Date 20 July 2016
Subject peer review Due Diligence Report

Port Lands Flood Protection and Enabling Infrastructure

Peer Review of Due Diligence Report

Examples of bridge design from water level experience perspective

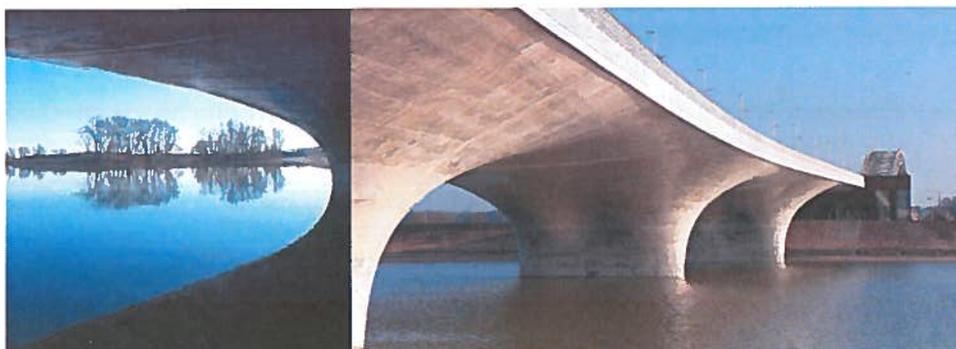
From that perspective, we have some concerns regarding the design criteria for the bridges set out in Appendix 1 to the Due Diligence Report. Only technical quality (such as durability and material selection) is described, but for instance no mention is made of the experience of bridge users or of the way these bridges should harmonize with their surroundings or even strengthen the identity of this unique urban river park.

Therefore, we recommend that the experience of the area from the water level perspective, which is a unique quality of the naturalized river area, be formulated as a design requirement for the bridges.

We recommend explicitly formulating ambitious design and spatial quality requirements that ensure the detailed design of the Project expresses the original vision and addresses key questions such as: what is the new unique identity of this whole new area? Why will people want to live and work here? Why will people from all over the world visit this area? The goal of making this area one of the uniquely situated areas in the world where residents of a metropolis can enjoy the benefits of living near a waterfront and actually touch the water in the flood plains should be a primary consideration in further design and further development.
